Traffic Engineering Letter

To	Platting 88 Pty Ltd	Date	17 April 2026
Prepared by	Kevin Liu, Modus Traffic Engineer	Approved by	Harj Singh, Modus Executive Director (RPEQ 22364)
Location	160 Miles Platting Road, Eight Mile Plains		
Subject	Proposed Subdivision Development - Traffic Engineering Letter		
Status	Final	Attachments	Appendix A: Council Further Advice Appendix B: Revised Development Plans Appendix C: Swept Path Assessment

RE: Further advice

DRAWING TITLE
**TURNAROUND PROVISIONS
 - STAGE 2 EASEMENT**

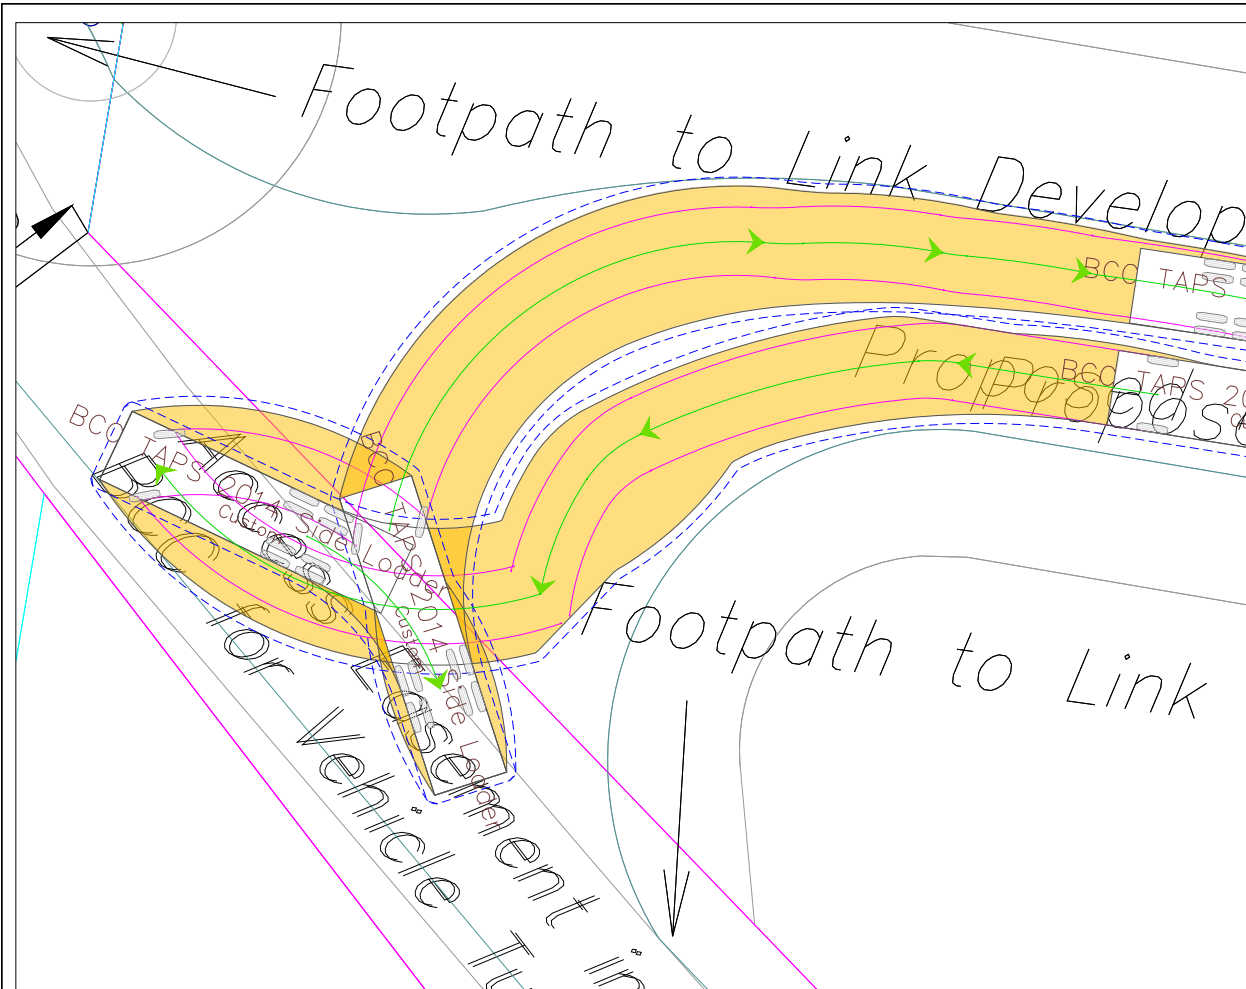
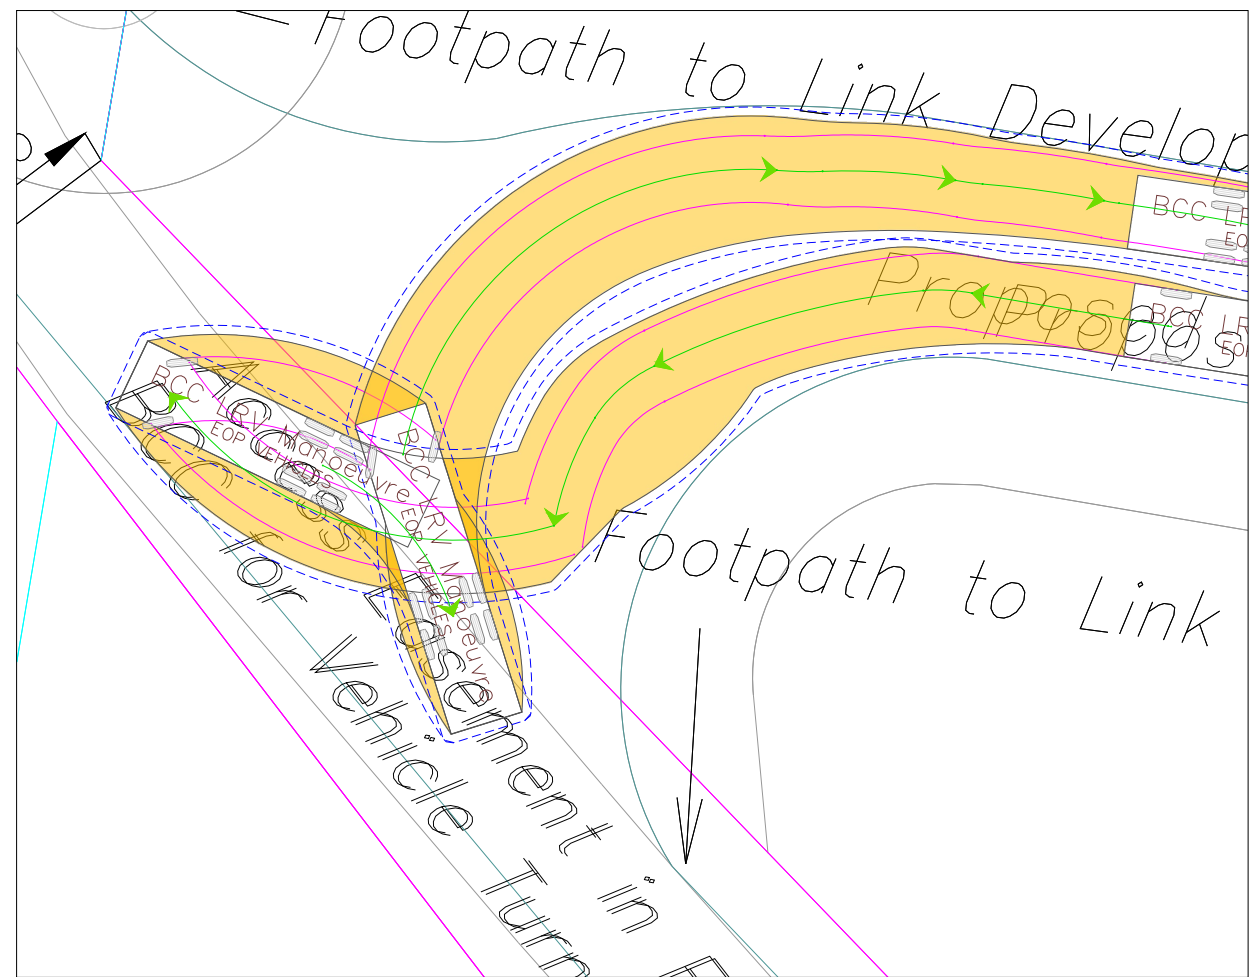
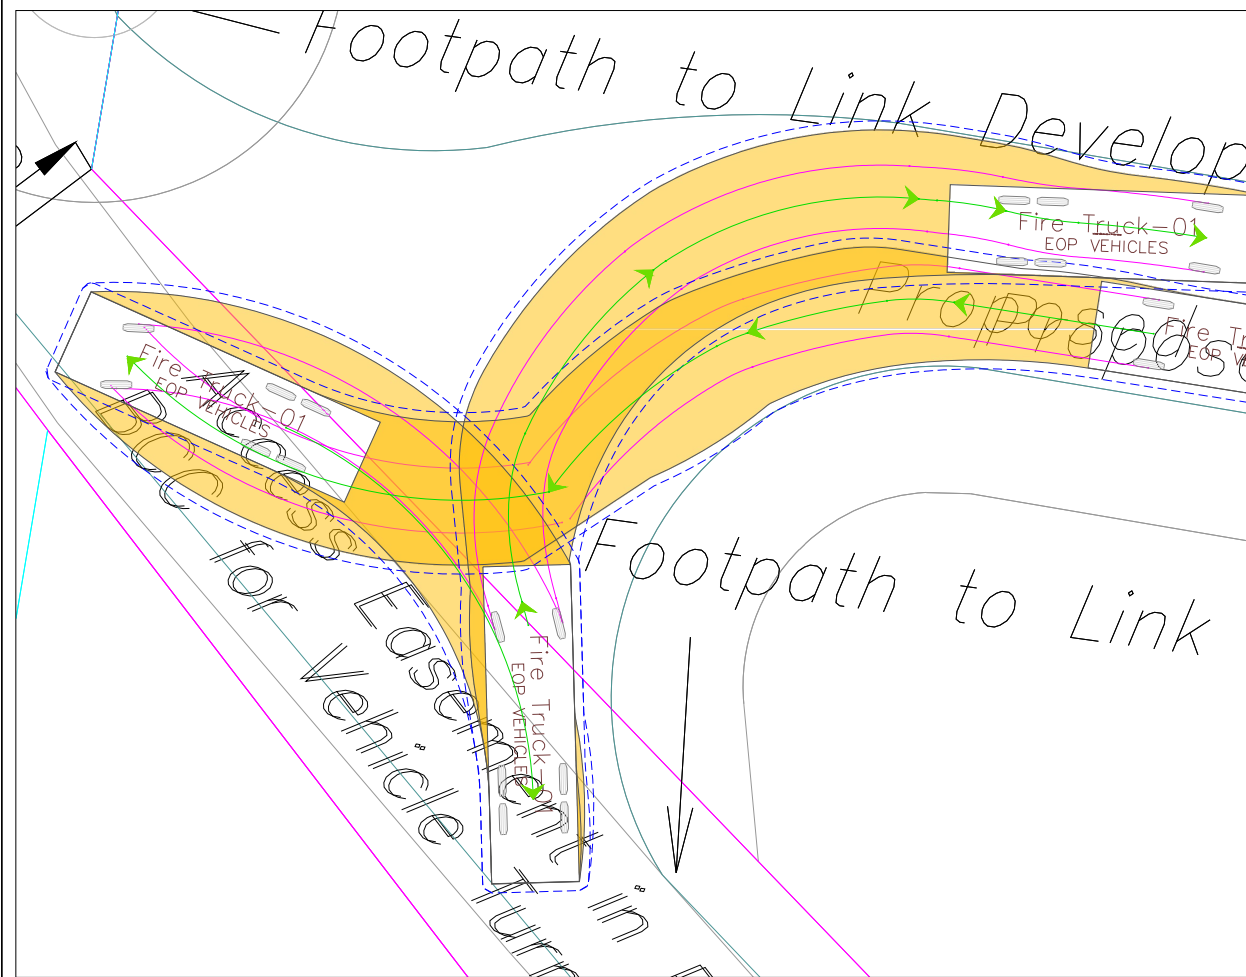
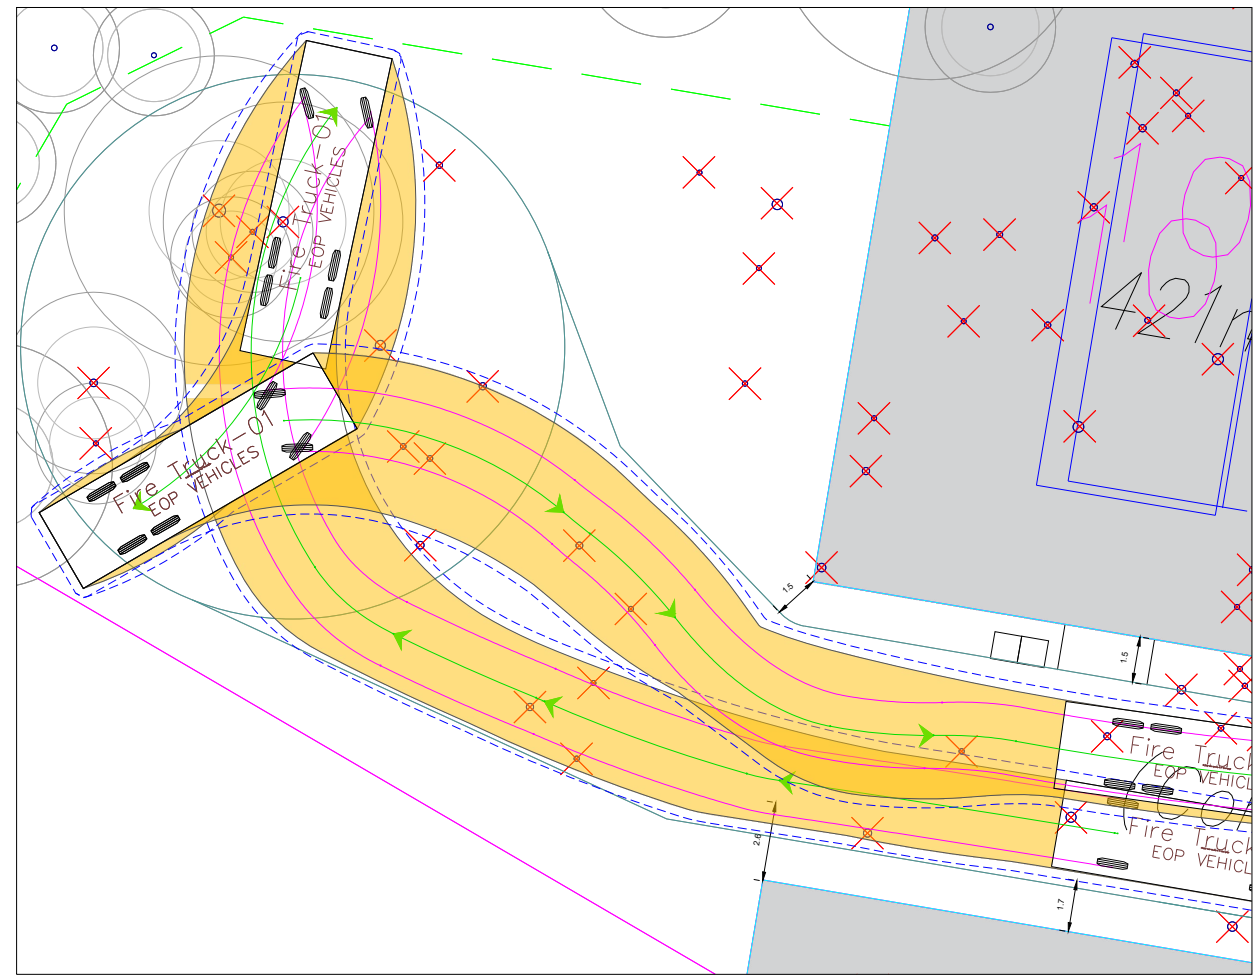
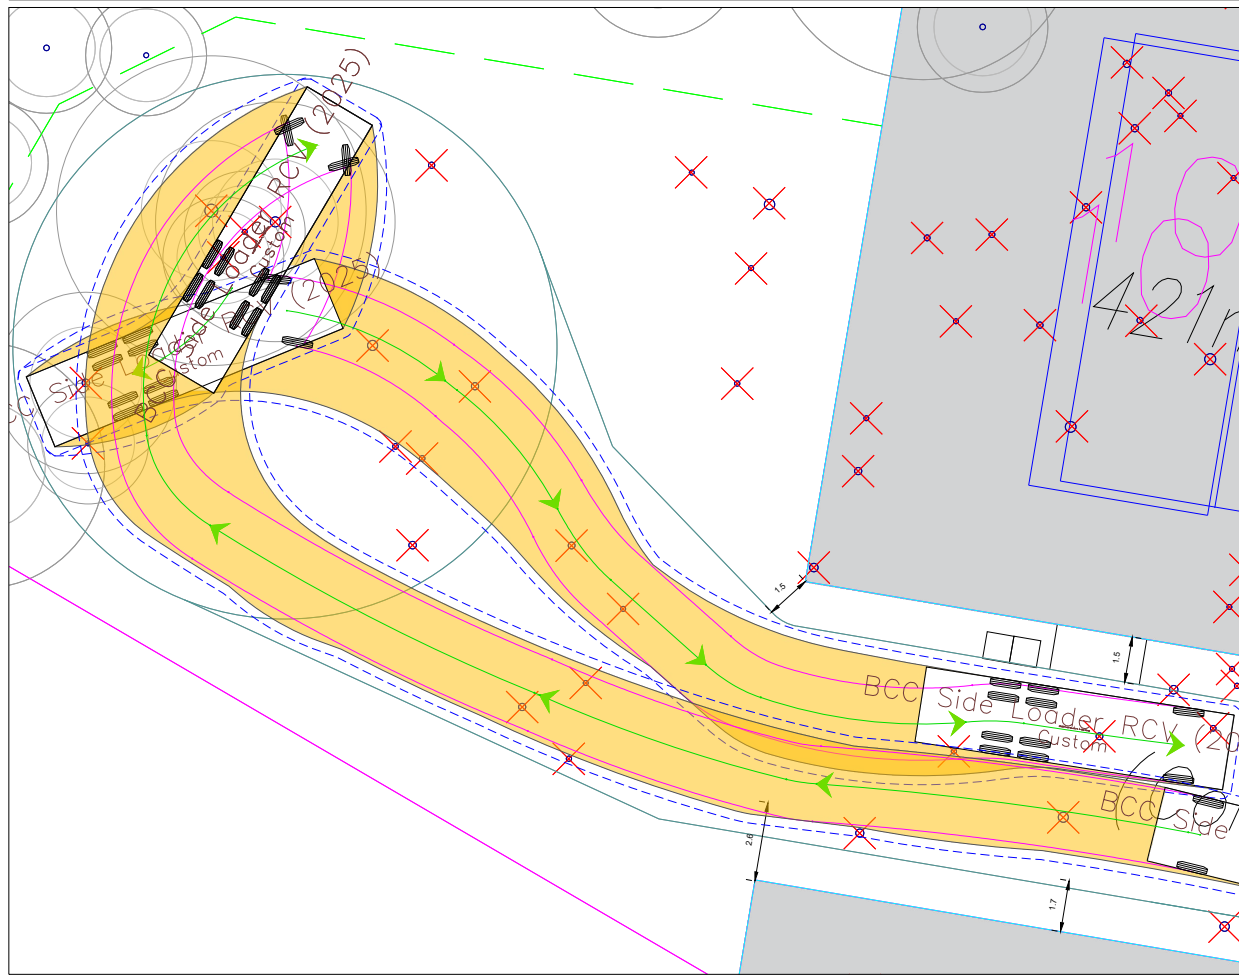
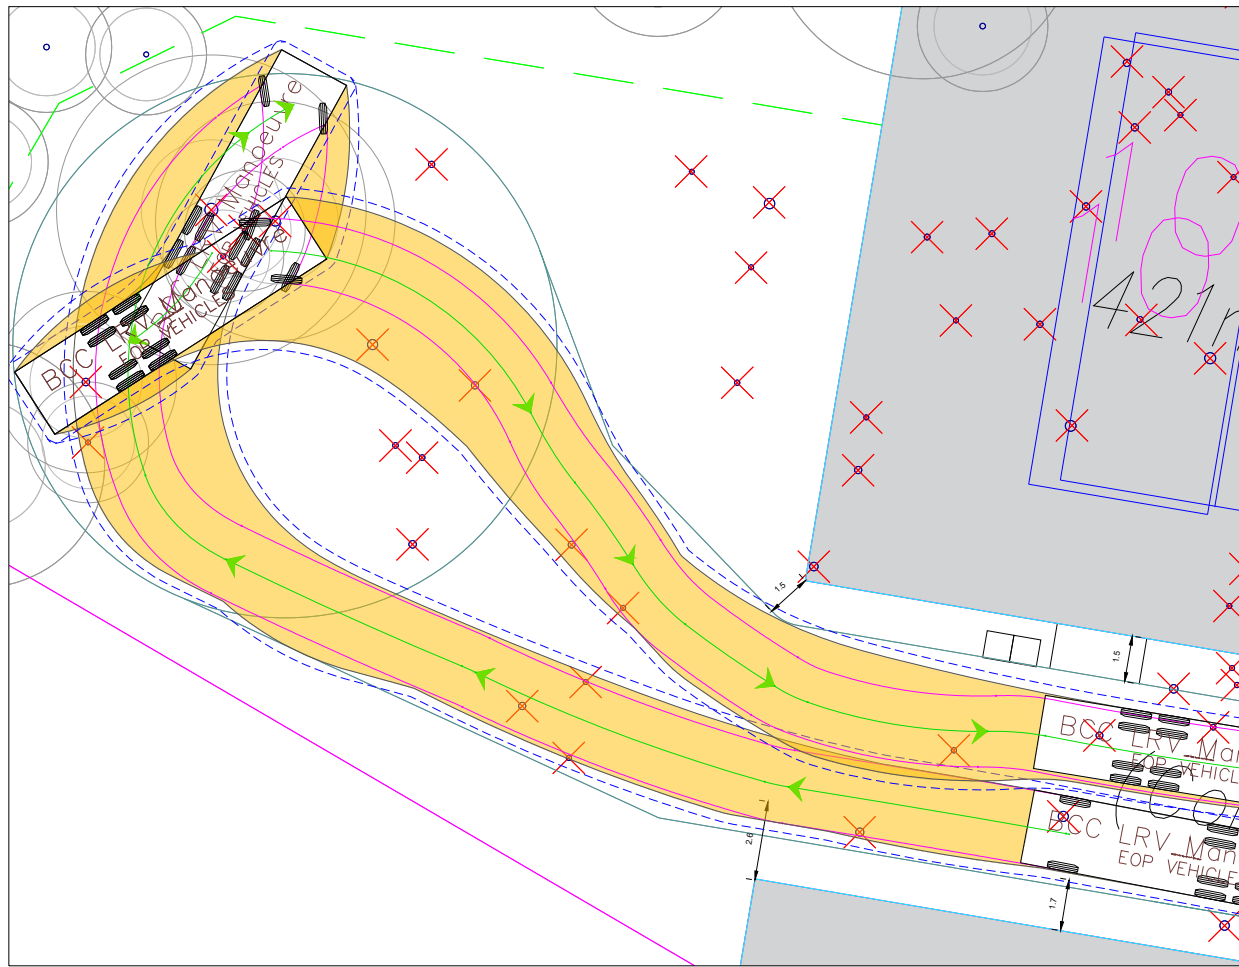
- a) Confirmation of the proposed sequencing of the development noting access to the site will need to be provided via approved development A006652684.*
- b) Amended plans which remove the proposed pedestrian and vehicle access from Miles Platting Road and illustrate the proposed cul-de-sac outcome currently shown as part of Stage 2.*

- ▶ Safe and compliant vehicular access,
 - ▶ A pedestrian safe path to the site,
 - ▶ Connectivity to the surrounding road network,
 - ▶ Appropriate linkage to the Eight Mile Plains Busway Station park and ride.
- b) Amended development plans have been prepared which:
 - ▶ Remove the previously proposed pedestrian and vehicle access to Miles Platting Road,
 - ▶ Stage 1 - turnaround provisions via a cul-de-sac and a 3-point turnaround within the easement (SK11),
 - ▶ Stage 2 - turnaround via the cul-de-sac.

Additionally, the swept path assessment demonstrates that the design service vehicles (LRV, RCV and Fire Truck) are able to turn around (via a three-point turn) at the end of each proposed cul-de-sac and within the easement. A copy of the swept path assessment is provided in **Appendix C**.
